Site Plan
1632 River Road
Puyallup, WA 98371

PROJECT NAME:
LEGEND AUTO ADDITION

PROJECT ADDRESS:
1632 RIVER ROAD
PUYALLUP WA 98371

S2.2

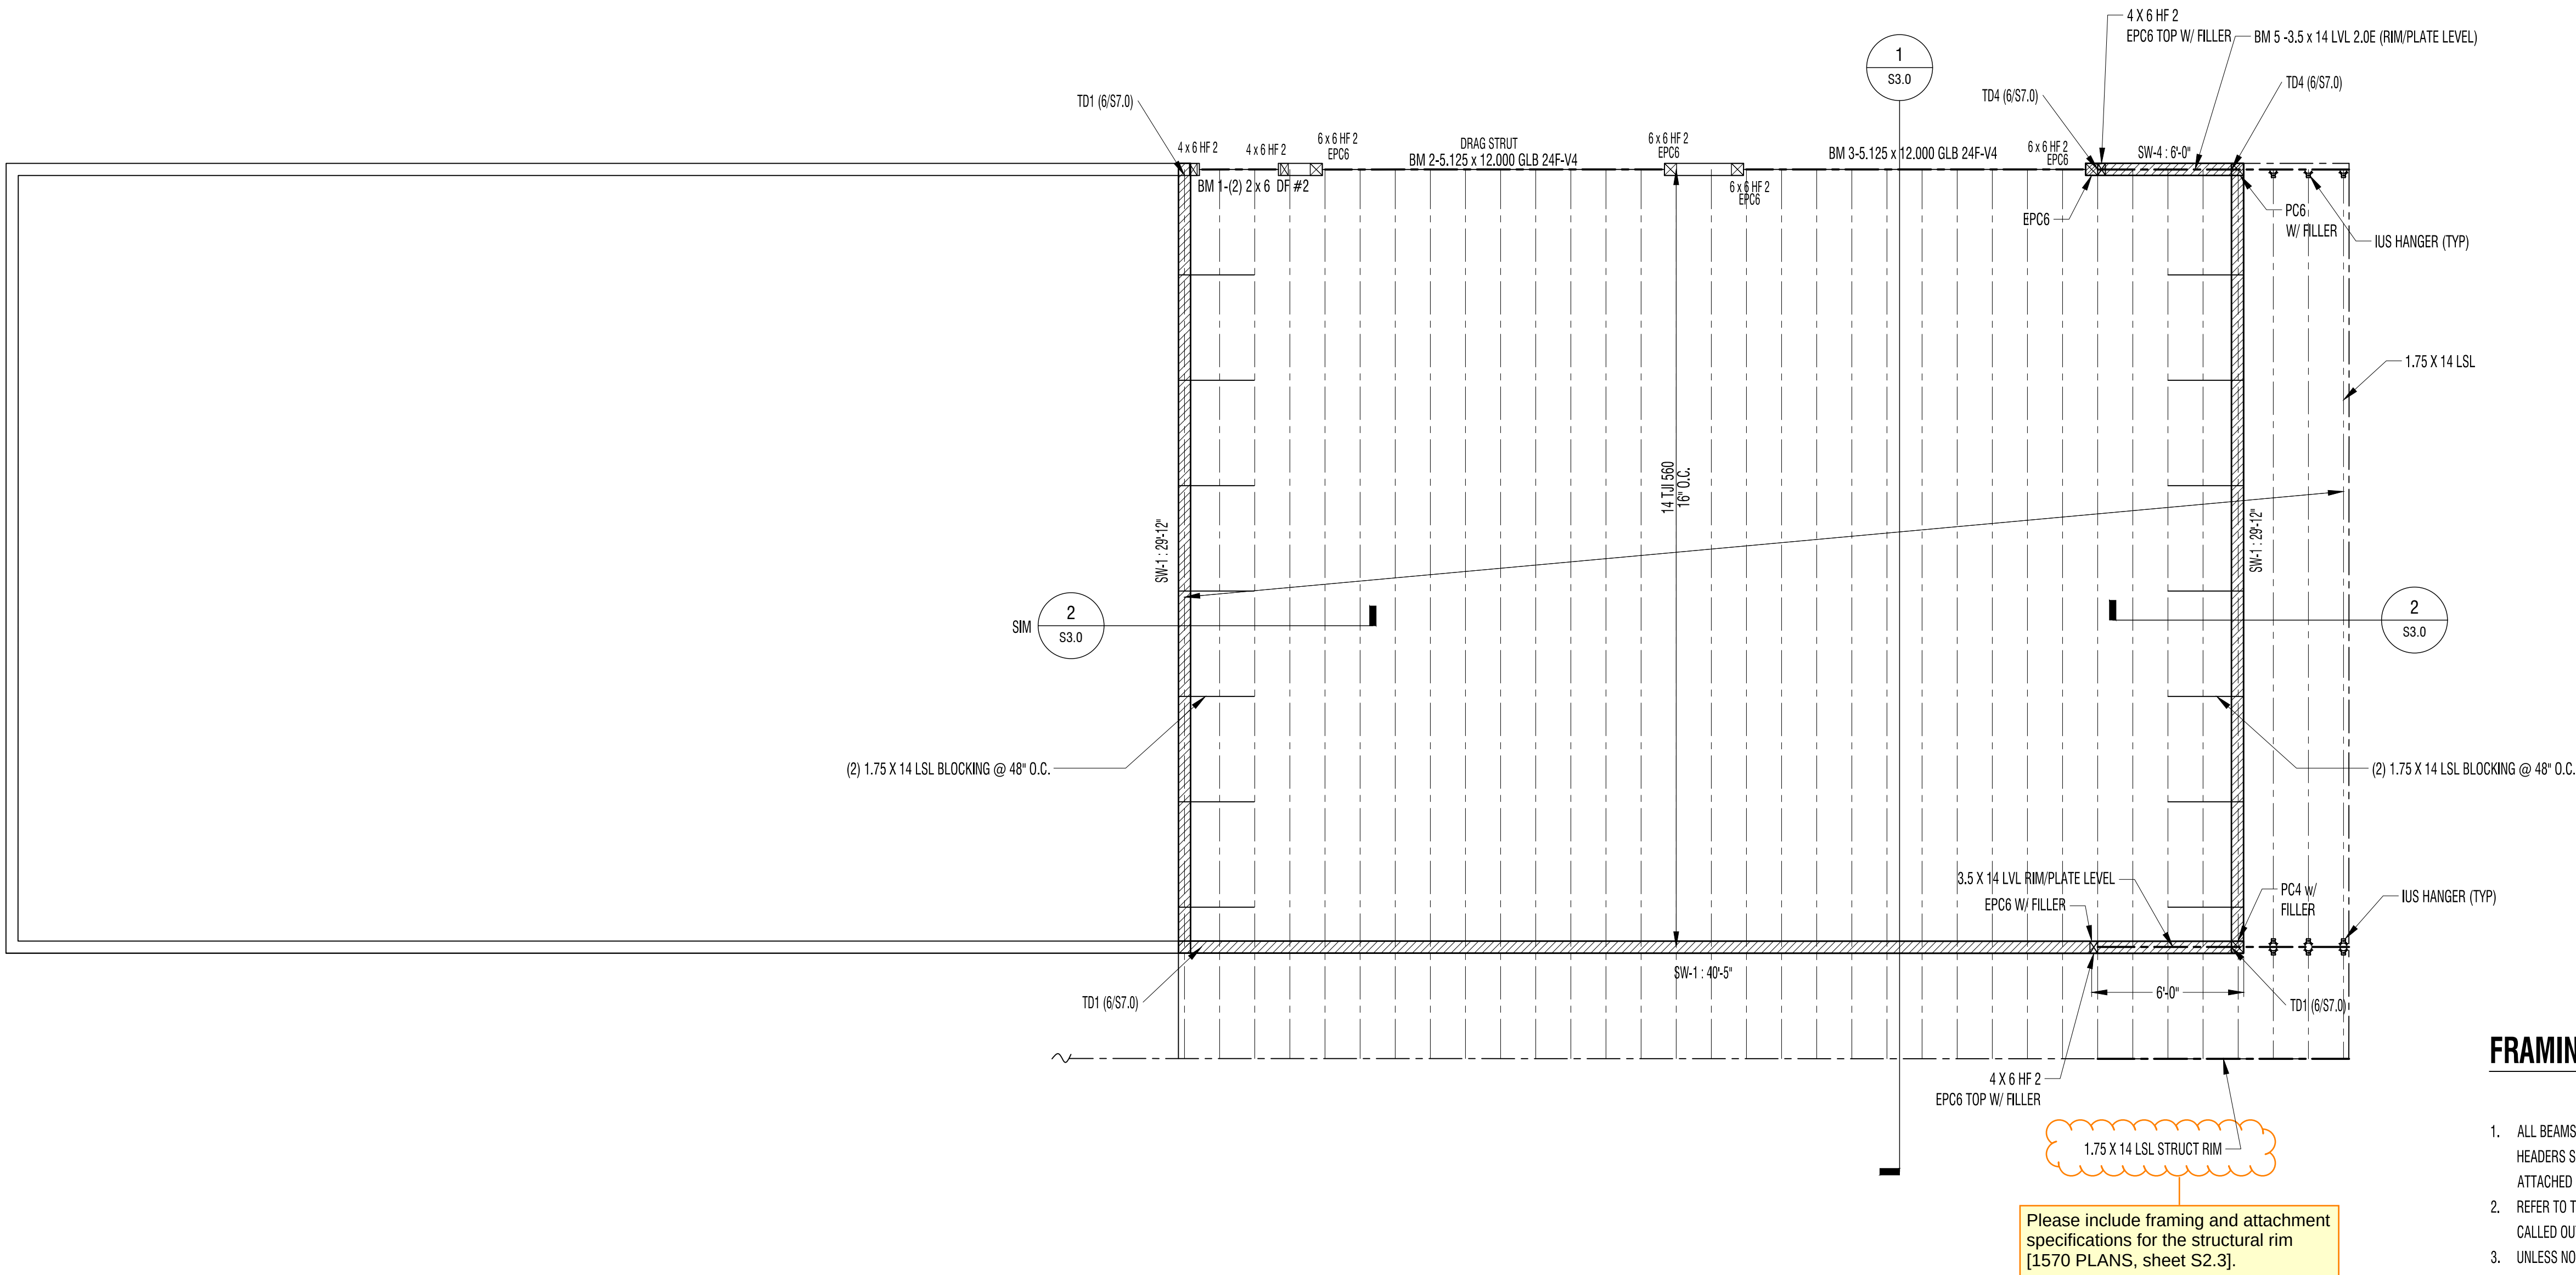
The existing building top plate and new addition top plate are not at the same elevation [1570 PLANS, sheet S2.2].

Please clarify how the shear and drag loads along this side of the building will be supported or transferred into the existing building [1570 PLANS, sheet S2.2].

The existing wall at this area will need to be retrofitted to match the new wall height. Please include framing requirements and specifications. [1570 PLANS, sheet S2.2].
